Project #: **1009600** *Application #:* 13DRB-70643

Project Name: **MCCAFFREY & WILLIS SUBD**

PROJECT TITLE
ALICE TOWNHOUSES FOR AHMET TIRYAKI
5600 ALICE AVENUE N.E.
ALBUQUERQUE, NEW MEXICO

Project# 1009600
13EPC-40097 Site Development Plan for Building Permit
13EPC-40098 Zone Map Amendment (Zone Change)
13EPC-40099 Site Development Plan for Subdivision
LEGAL DESCRIPTION:
For all or a portion of Lots 7, 8, 9, 10, 11 & 12, Tract 14, Mile Hi Addition, Willis Subdivision & 7, 8 & 9, Tract 13, Mile Hi Addition, McCaffrey Subdivison, located at 5600 Alice Avenue NE, between Alvarado and Cardenas, containing approximately 1.38 acres.
Staff Planner: Chris Hyer

DRAWING NO.
DRB-1

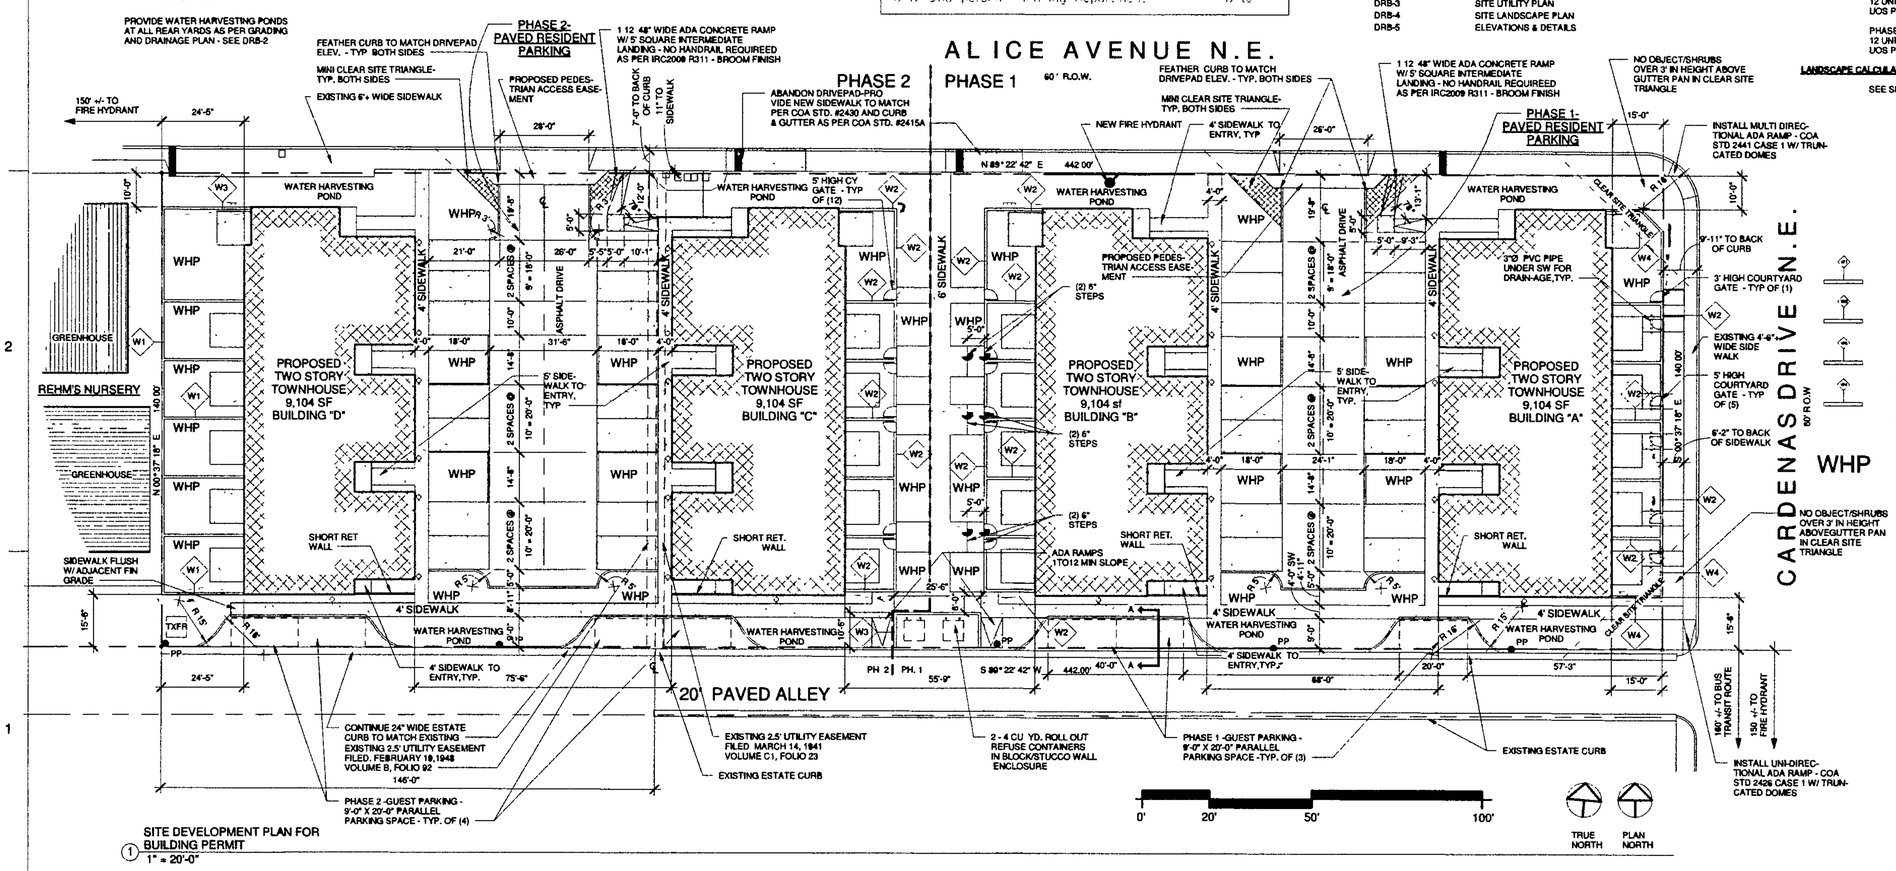
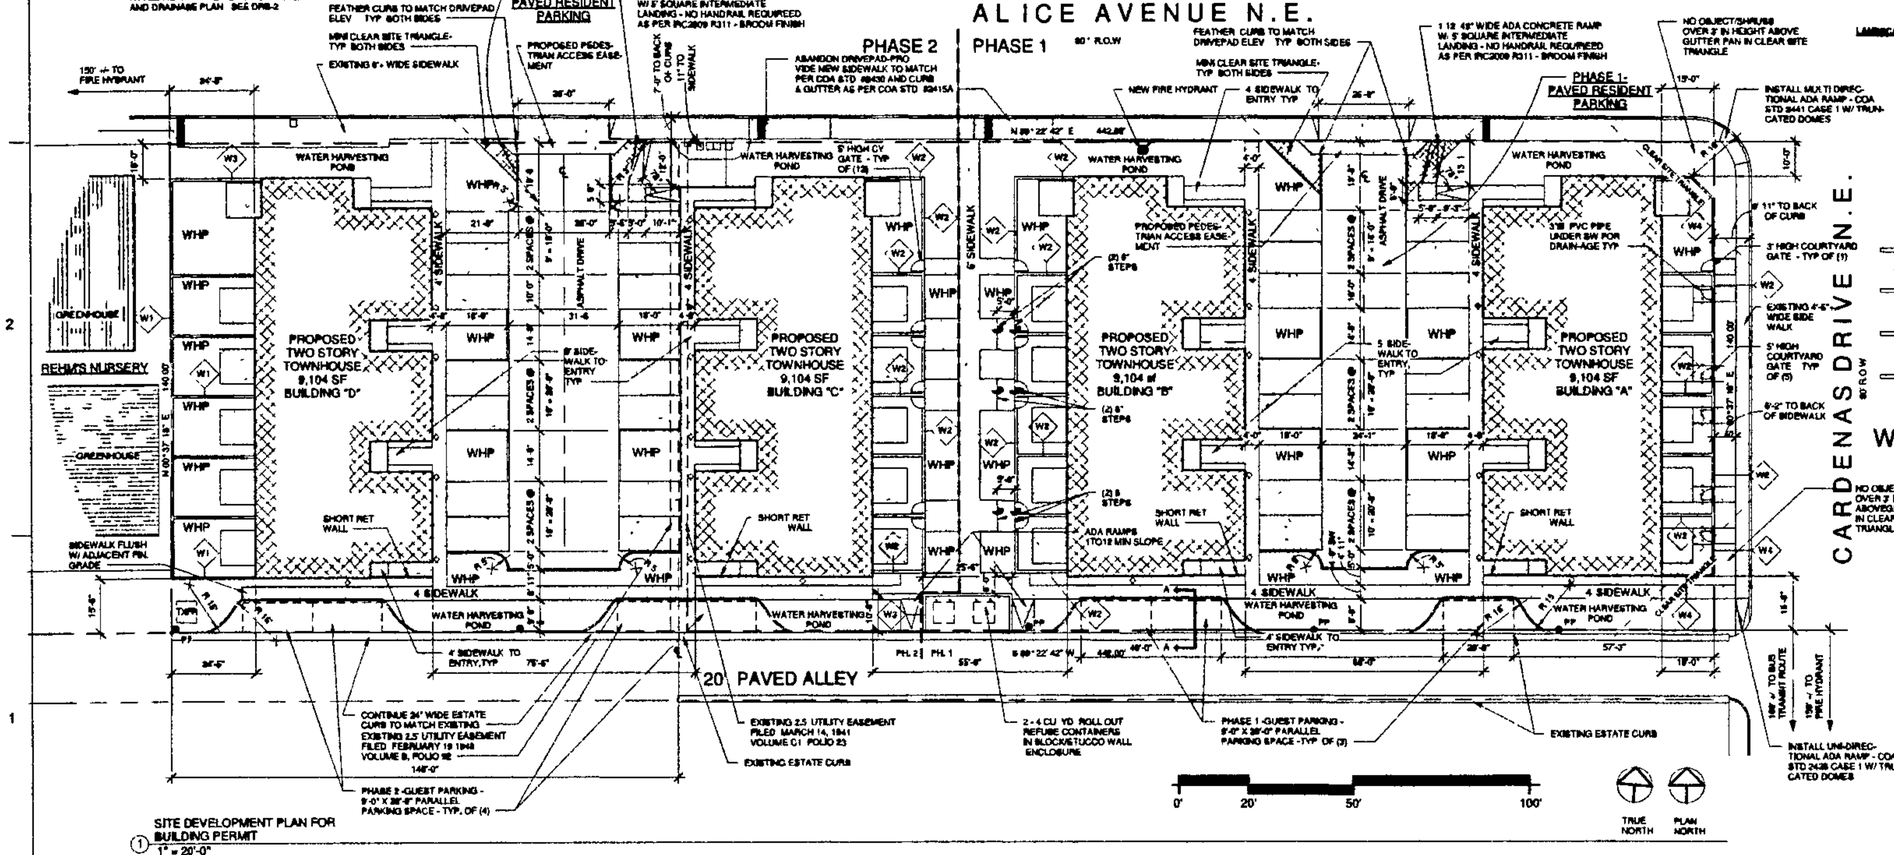
3. Conditions from City Engineer, Municipal Development, Water Authority and NMDOT:
   a. Provide/label/detail all dimensions, classifications and proposed infrastructure within the site. (Include drive pad/ADA sidewalk, sidewalk/fire hydrant location, refuse gates, curbs, tie-in details, ADA ramps).

b. Site plan shall comply and be in accordance with DPM (Development Process Manual) and current ADA standards/ requirements.
   c. All easements and access agreements must be shown and labeled on Site Plan. Provide recording information.

d. Add the following note to the Landscaping Plan: "Landscaping and signing will not interfere with clear sight requirements. Therefore, signs, walls, trees, and shrubbery between 3 and 8 feet tall (as measured from the gutter pan) will not be acceptable in this area."

e. Please revise courtyard wall heights to comply with DPM standards for clear sight triangle requirements.
   f. Roof flows of building D shall drain to the east or be guttered to drain to Alice Ave. The courtyard areas of building D could then pond what falls on them.

3. Conditions from various department
   a. Provide and label and detail all infrastructure and easements on site plan

We have labeled all relevant on site plan

b. Site plan shall comply with DPM and ADA

We feel the site plan meets DPM and ADA standards

We have shown all existing easements, the site plan for subdivision was most appropriate place for many of the proposed easements for clarity

d. Add not to landscape plan regarding clear site triangle

This note has been added to the Mylar, the paper copies were made prior to addition, the Mylar will be presented at DRB.

e. Revise courtyard walls to comply with DPM

We have revised the walls and labeled the clear site areas
